RICHLAND HIGH SCHOOL DETENTION BASIN FOR GRANT PROJECT CFPF 24-04-32 TAZEWELL COUNTY, VA

VICINITY MAP

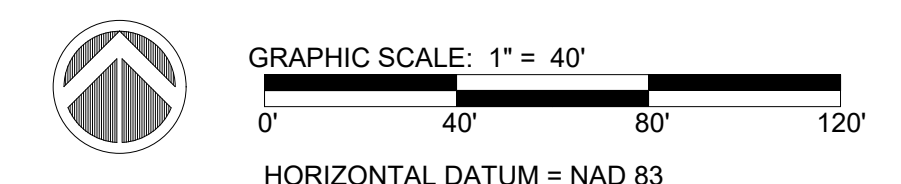
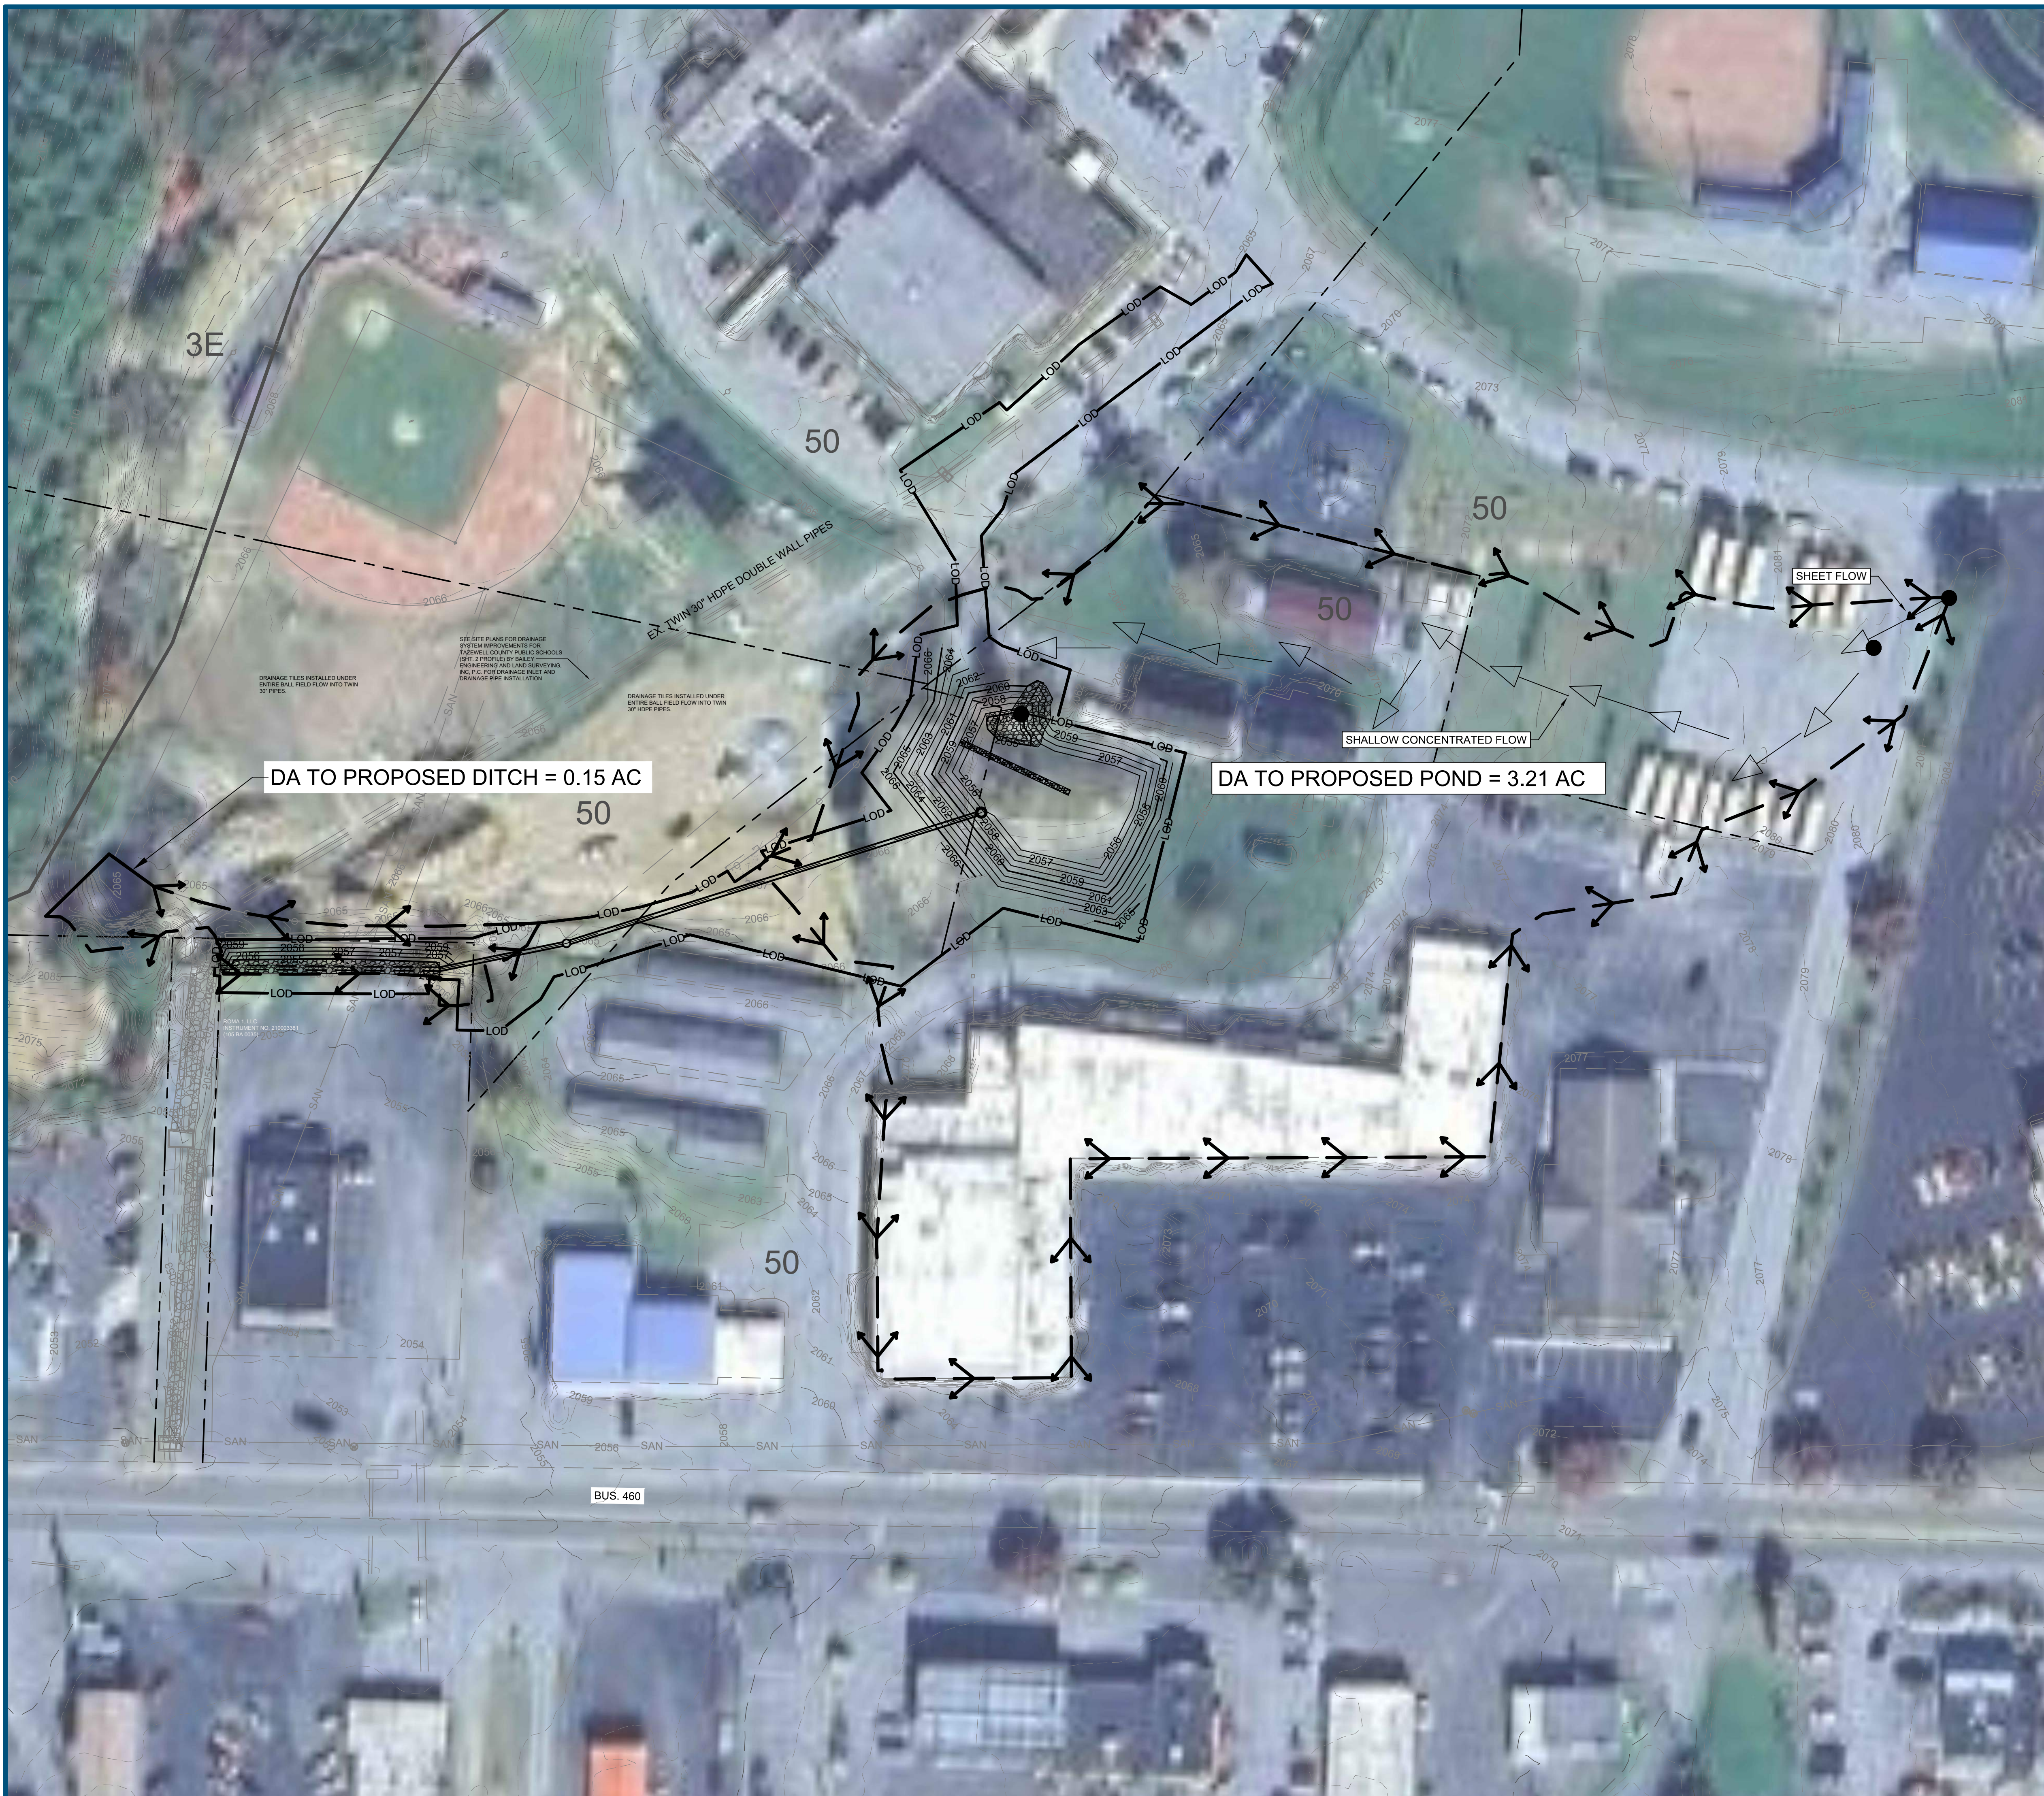
CONSTRUCTION PLAN REVIEW
Signature Date

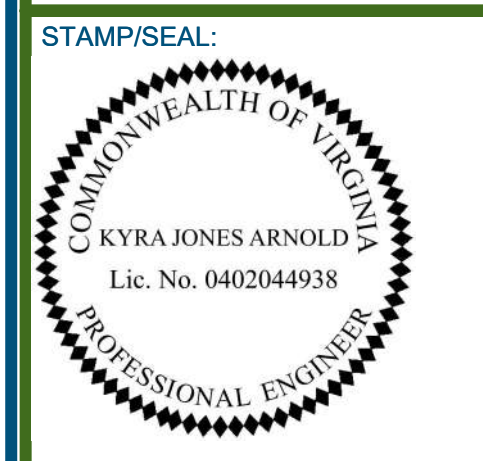
30% DESIGN REVIEW	
BAILEY WILFONG	03/13/2026
Signature	Date
PERMIT PLAN DESIGN REVIEW	
BAILEY WILFONG	05/01/2026
Signature	Date
CONSTRUCTION PLAN REVIEW	
---	---
Signature	Date
REVISIONS:

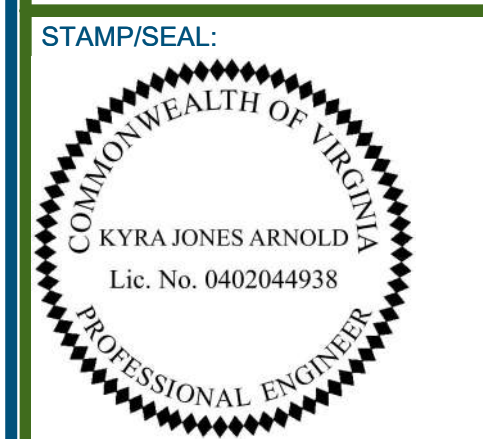
30% DESIGN REVIEW
BAILEY WILFONG 03/13/2026
Signature Date
PERMIT PLAN DESIGN REVIEW
BAILEY WILFONG 05/01/2026
Signature Date
CONSTRUCTION PLAN REVIEW

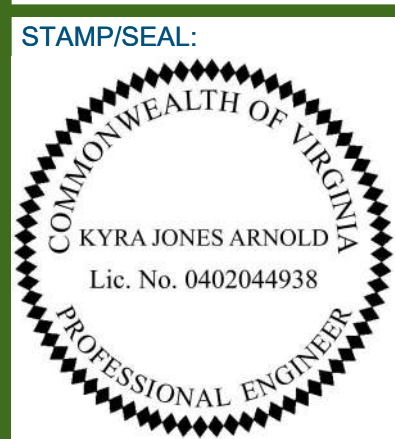
Table with 2 columns: Review Stage, Date. Rows include 30% DESIGN REVIEW, PERMIT PLAN DESIGN REVIEW, CONSTRUCTION PLAN REVIEW, and REVISIONS.
